DESIGN <i>CP</i>	DRAWN BY <i>CP</i>	DART AEROSPACE LTD HAWKESBURY, ONTARIO, CANADA	
CHECKED <i>H</i>	APPROVED <i>H</i>	DRAWING NO. DSI 9202	REV. A SHEET 1 OF 1
DATE 01.04.20		TITLE BASKET HINGE CHANGE	SCALE NTS
A	01.04.20	NEW ISSUE

DART SERVICE INSTRUCTION

TO AMEND INSTALLATION DRAWING D205-541 REV. D
(REF. CANADIAN STC: SH96-120, FAA STC: SR00696NY)
AND INSTALLATION DRAWING D350-607 REV. E
(REF. CANADIAN STC: SH94-14, FAA STC: SR00213NY)

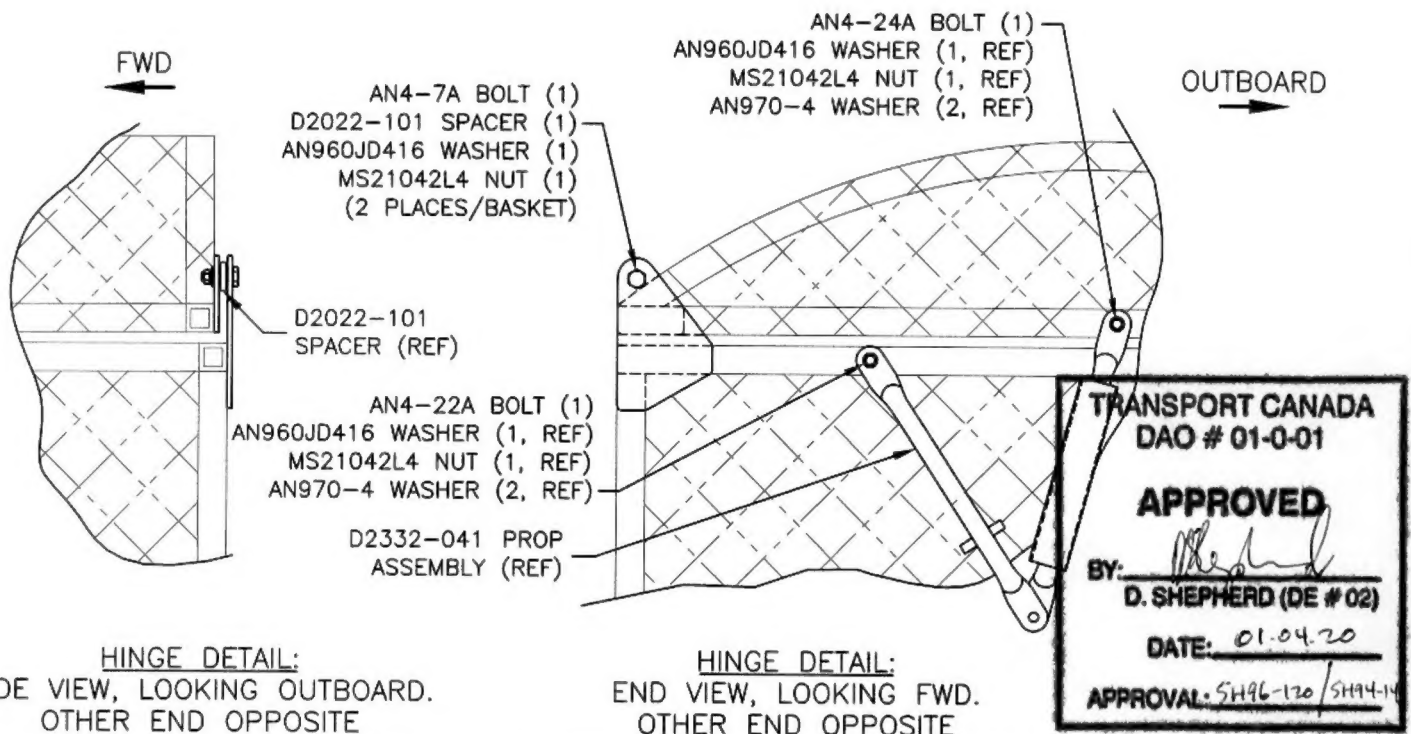
THE PARTS LIST OF D205-541 REV. D (205-541-041 CHG 004 OR LATER) / D350-607 REV. E (D350-607-041/-042 CHG 005 OR LATER) SHOULD BE AMENDED AS FOLLOWS:

REMOVE:

Qty	Part Number	Description
1	D2569	HINGE
36	AD64ABSLF	RIVET
1	AN4-22A	BOLT*

* NOTE: AN4-22A SUBSTITUTED FOR AN4-23A PER DSI 9159 REV. A
ON D205-541-041

ADD:

Qty	Part Number	Description
2	D2022-101	SPACER
2	AN4-7A	BOLT
1	AN4-24A	BOLT
2	AN960JD416	WASHER
2	MS21042L4	NUT (OR MS21042-4)
